CHRYSLER

September 2013

## **Customer Satisfaction Notification N03 Tire Pressure Monitor & Overlay Label**

2013 (FF) Fiat 500 Sport Turbo

Figure 2 – Tire and Loading Information Label with Tire Pressure Overlay Label Location

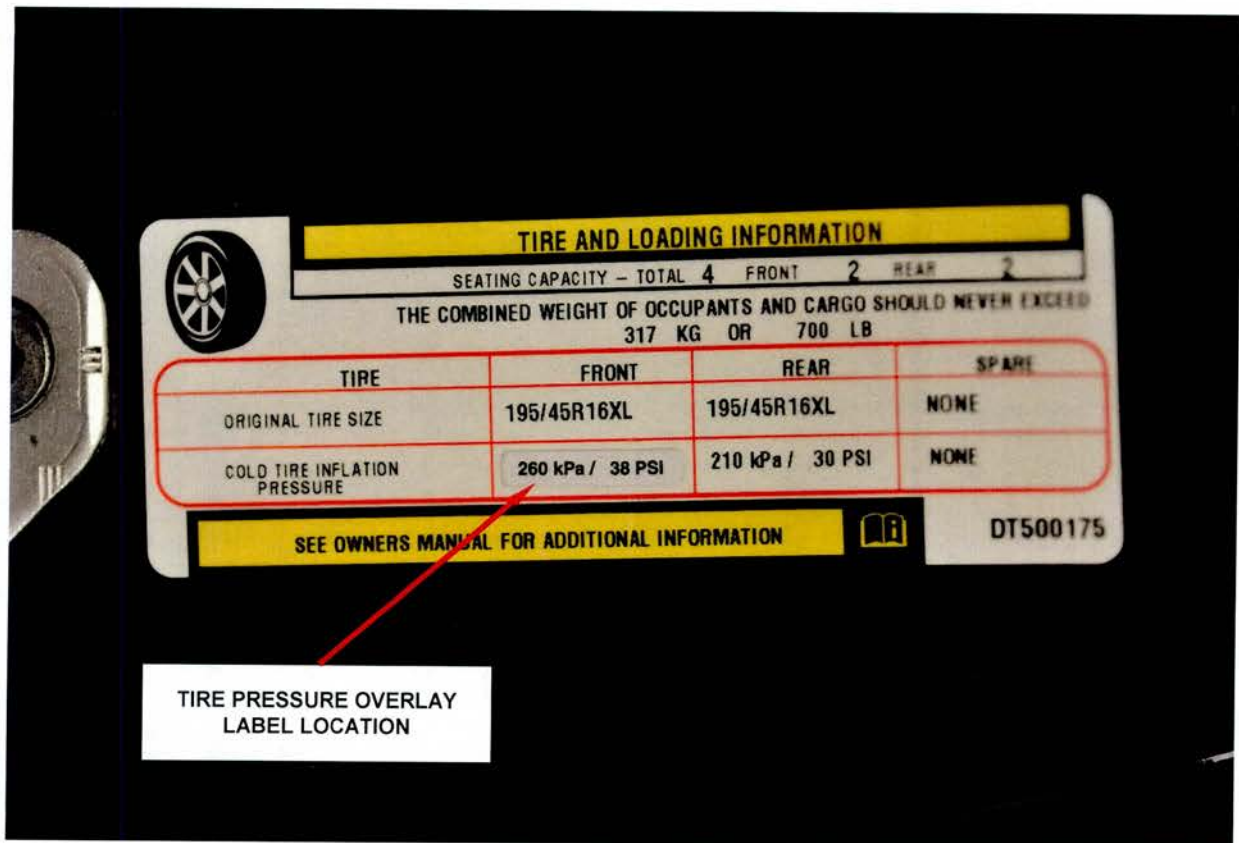
- 3. Remove the Tire Pressure Overlay Label from its paper backing and carefully install it over the Tire and Loading Information Label, covering the incorrect front tire inflation pressure information (Figure 2). Firmly press and smooth the Tire Pressure Overlay Label to the surface of the Tire and Loading Information Label to ensure good adhesion.
